Bid Addendum No. 1 for:

MASON TRANSIT AUTHORITY – PEAR ORCHARD PARK AND RIDE PROJECT

All Bidders are required to make the following substitutions to the Bid Documents. Below is a description of the revisions made to the Contract Documents.

DRAWING No.:
CV

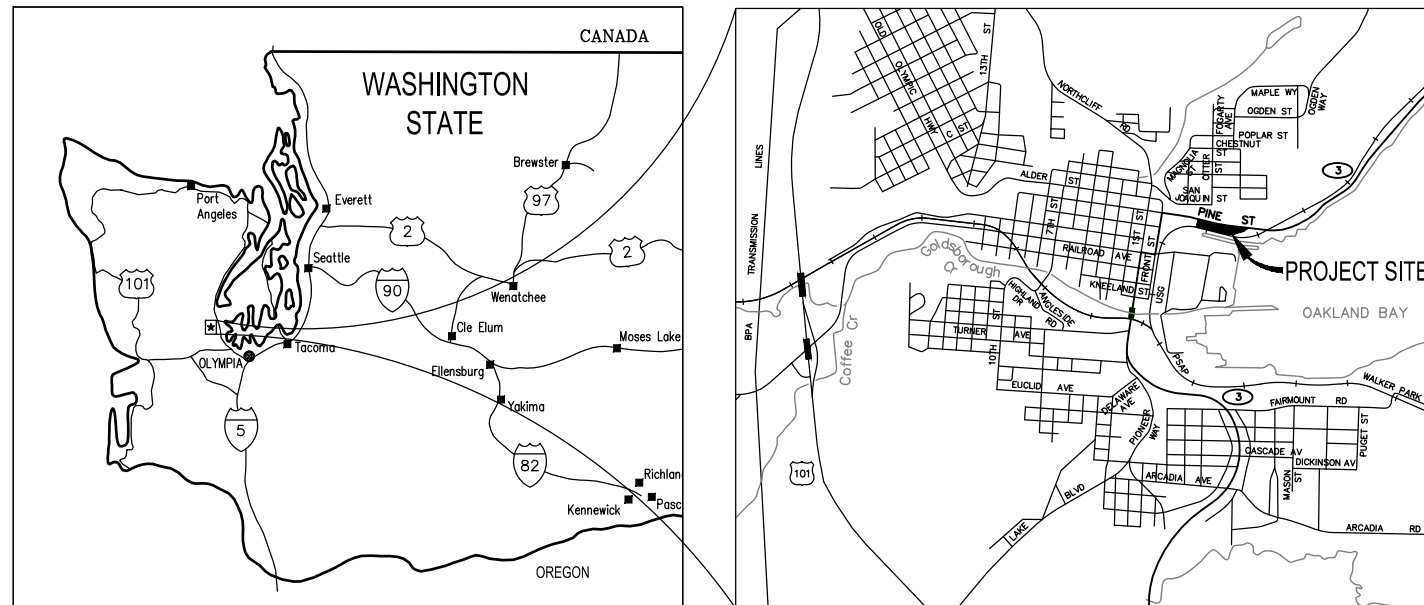
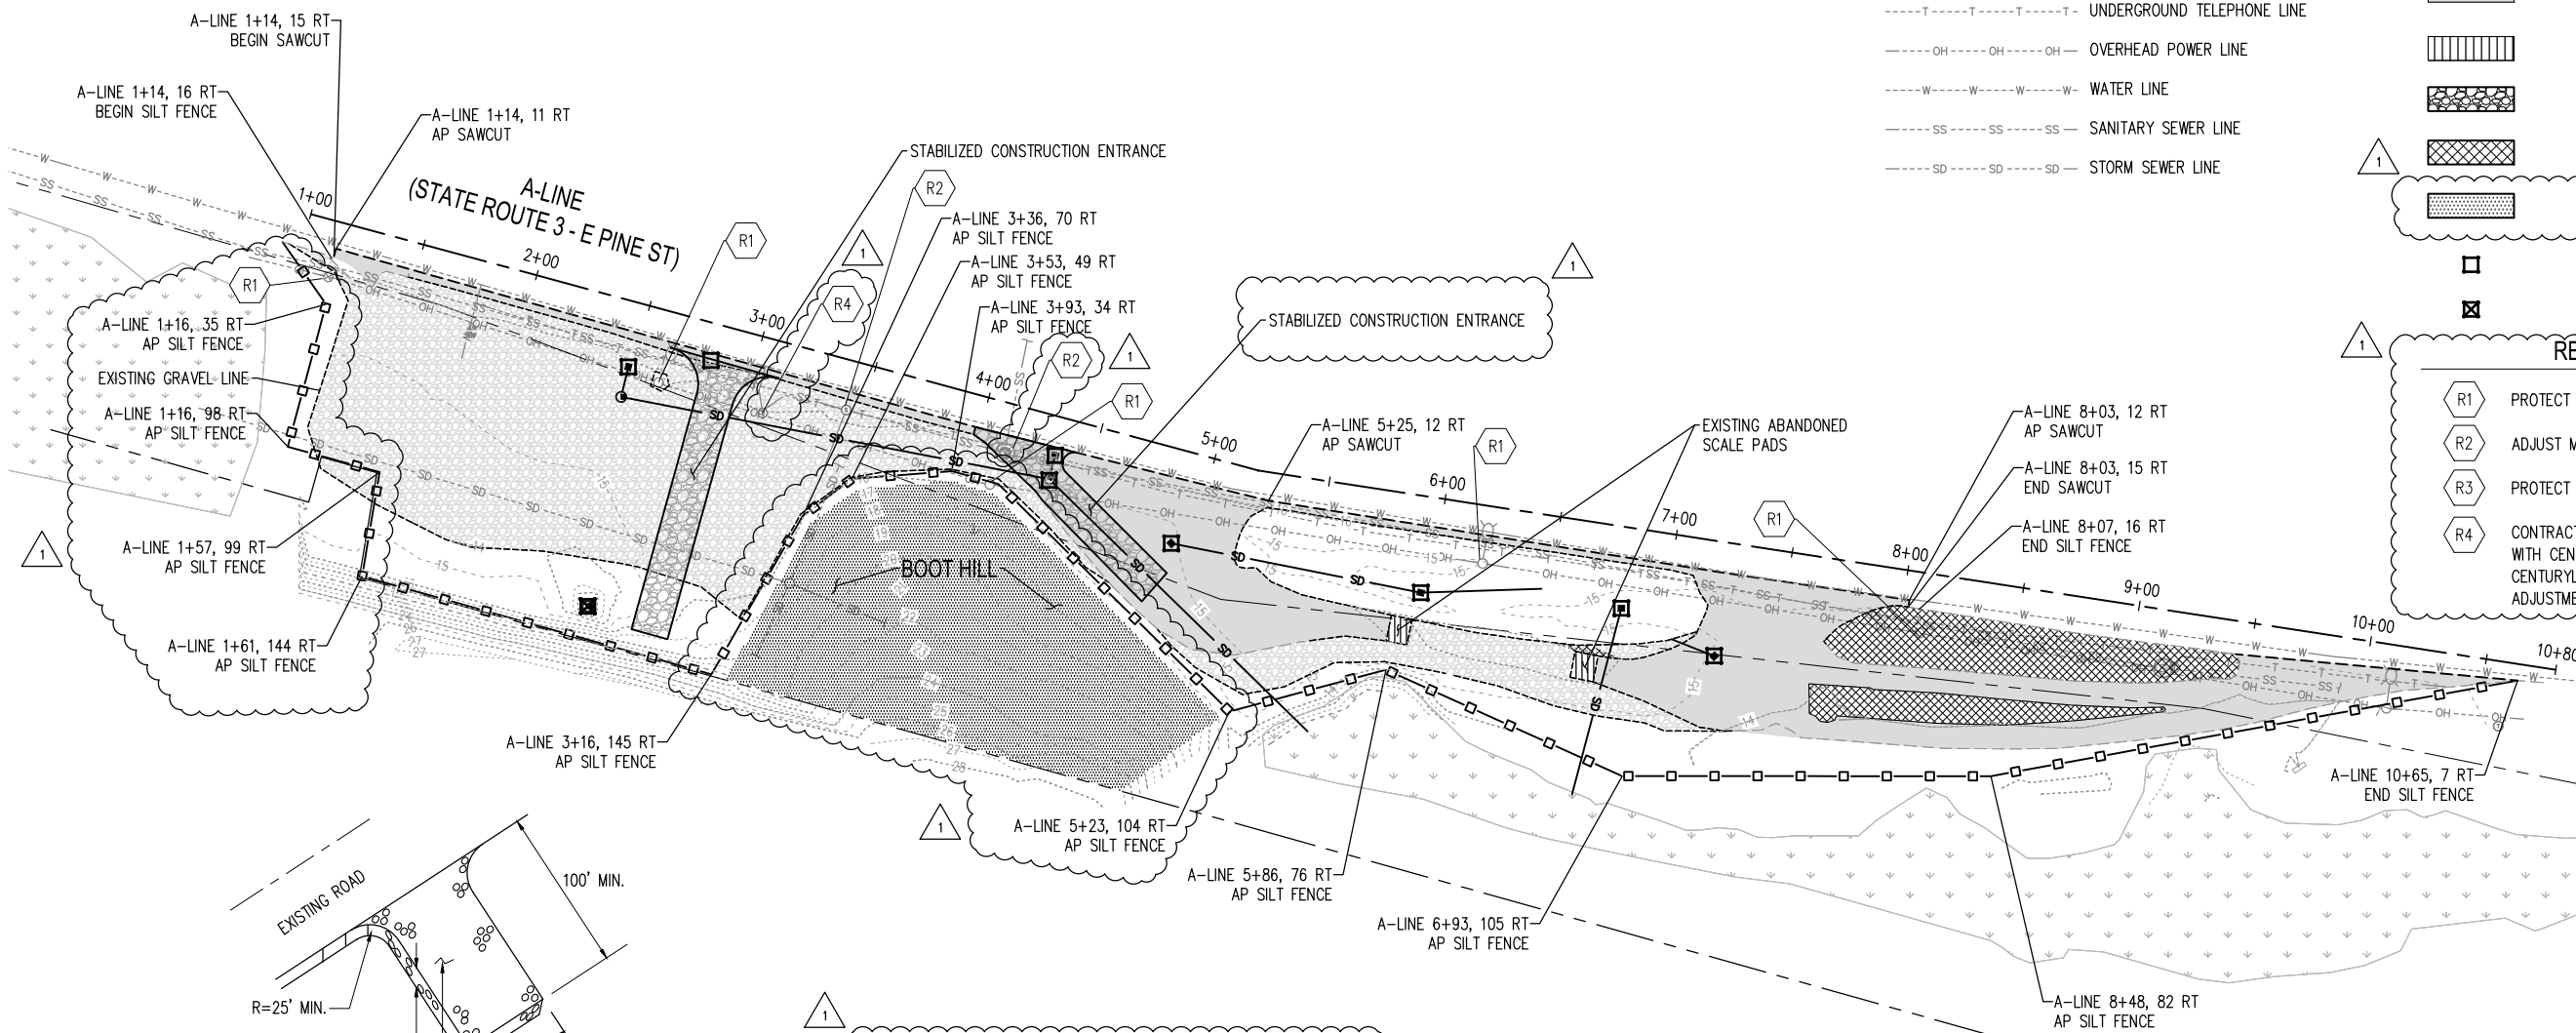
- Added Northing and Easting to Datum control points.
- Updated Sheet Index

DRAWING No.:
EC-1
SHEET No.:
3 OF 23

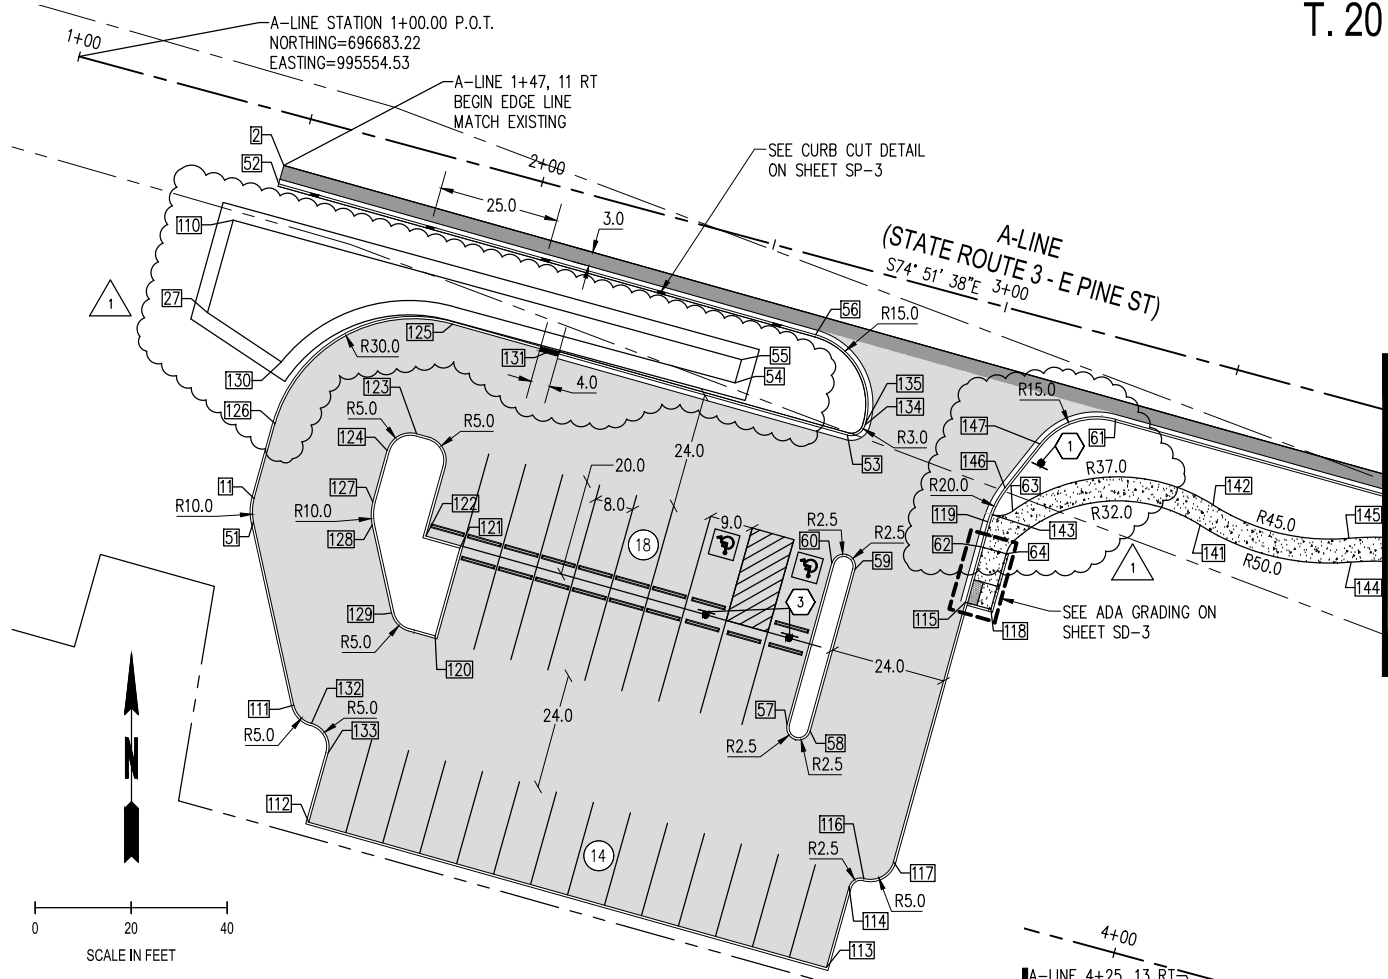
- Revised silt fence.
- Clarified limits of Boot Hill and added Note regarding soil contamination.
- Added note for contractor to coordinate with CenturyLink for manhole adjustment.

DRAWING No.: SP-1
 SHEET No.: 5 OF 23

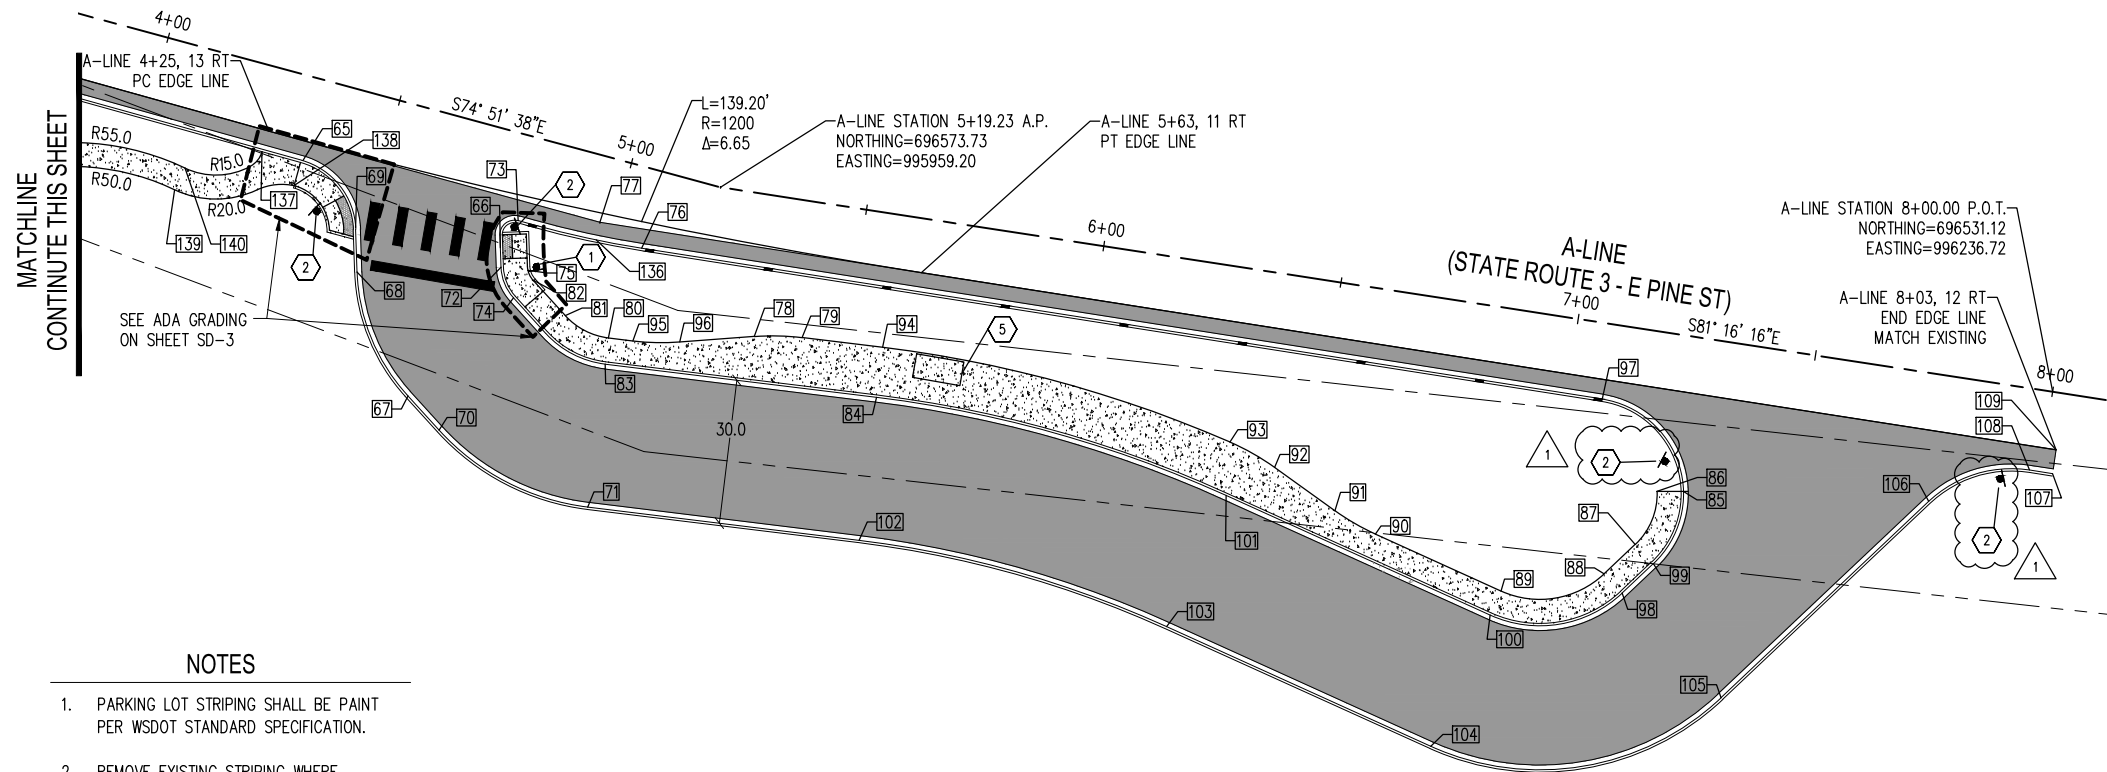
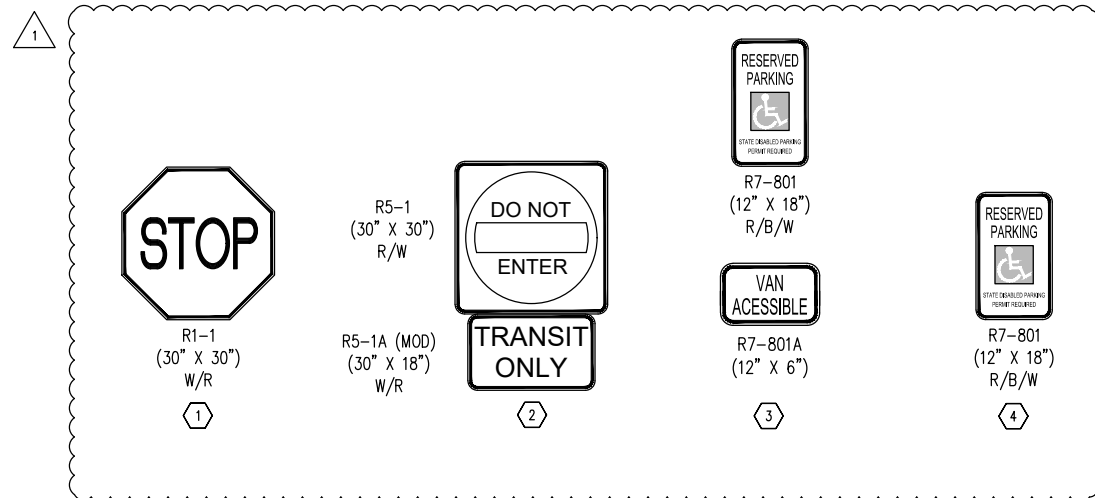
- Revised parking lot curb return geometry.
- Revised pond geometry.
- Updated sign callouts.

DRAWING No.: SP-3
SHEET No.: 7 OF 23

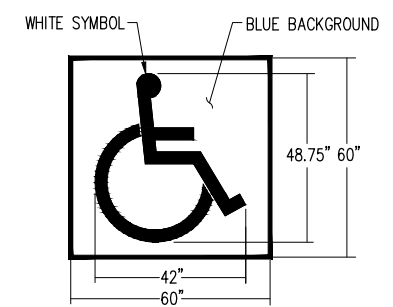
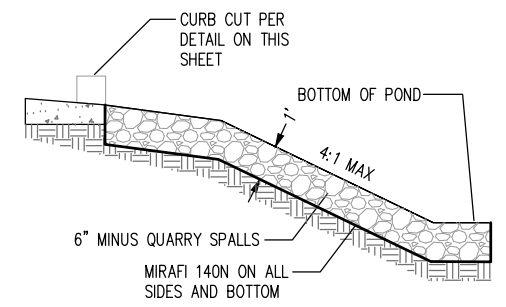
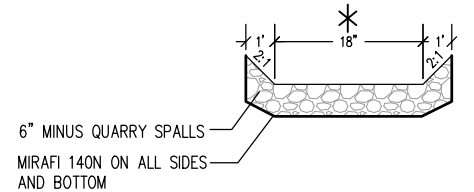
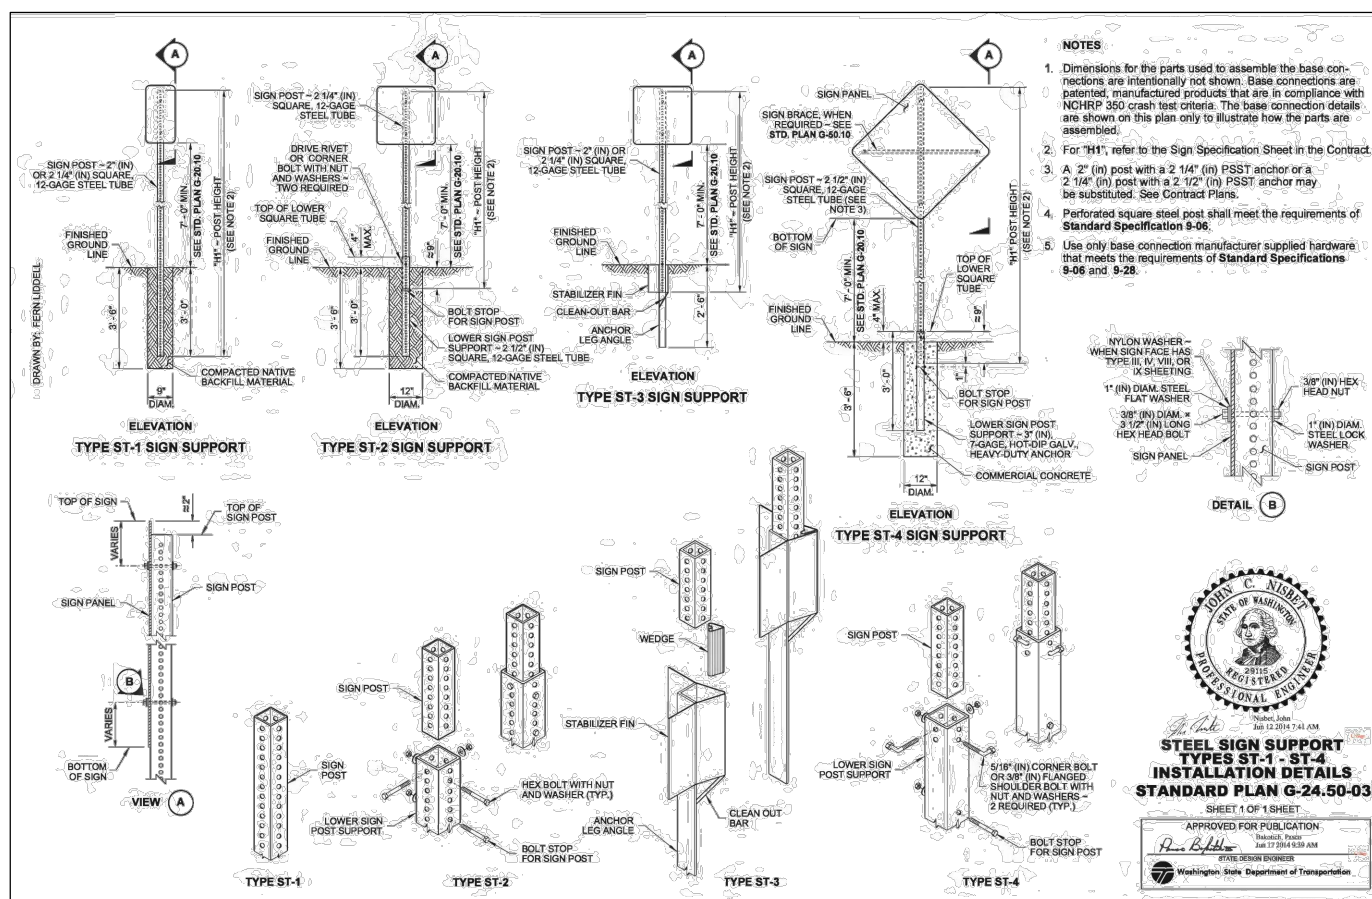
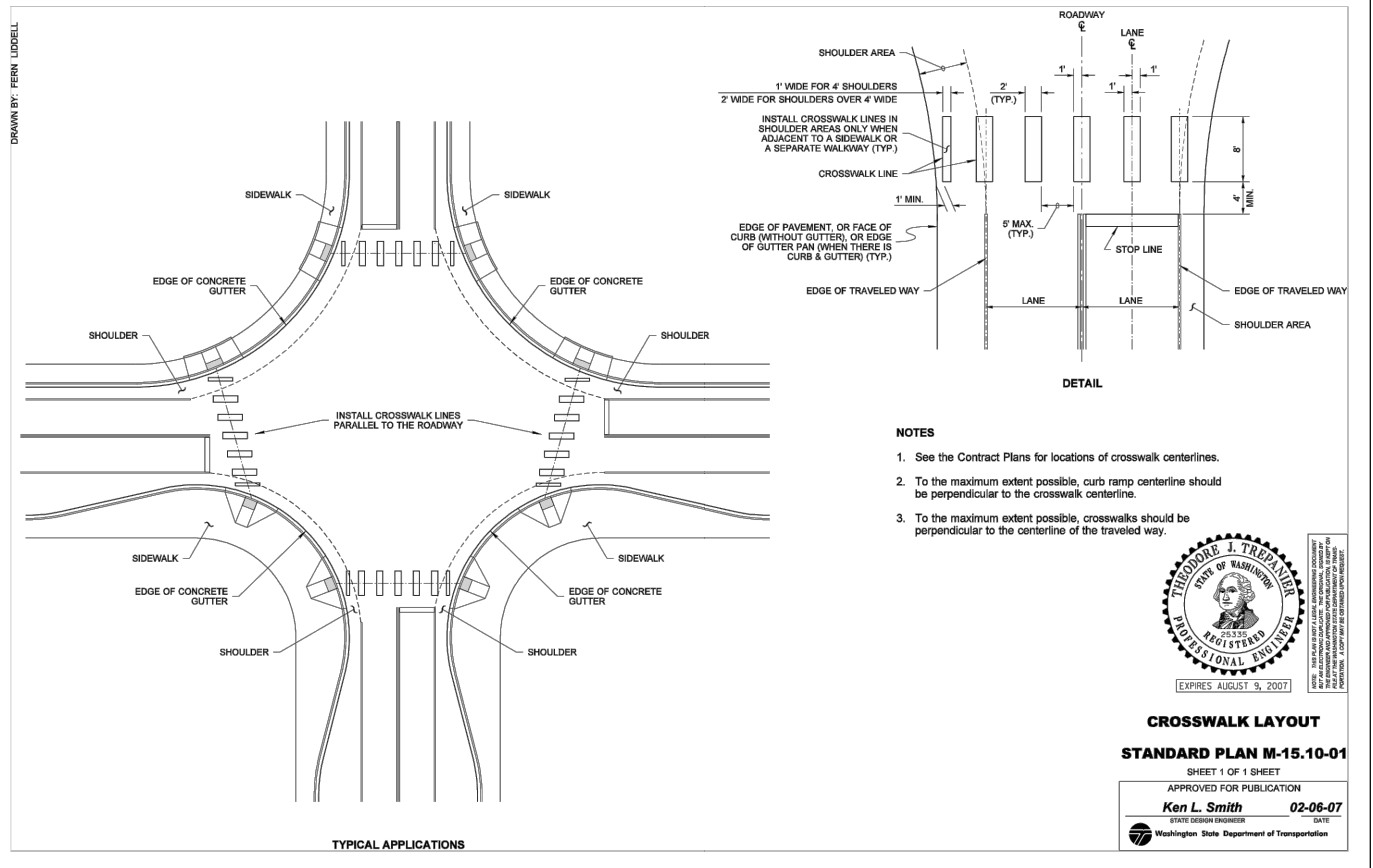
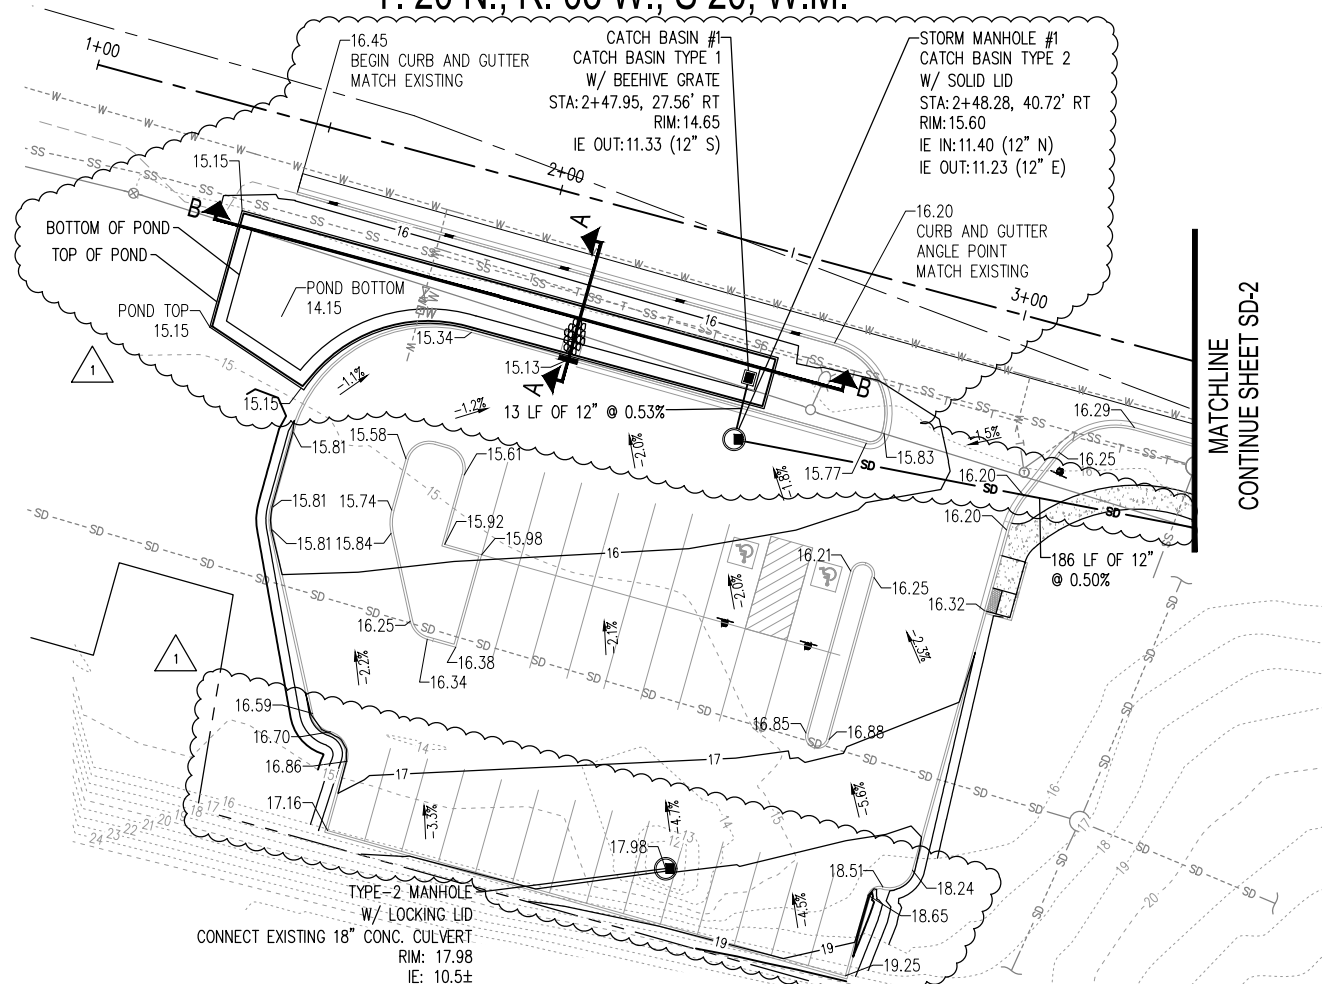
- Revised sign details.
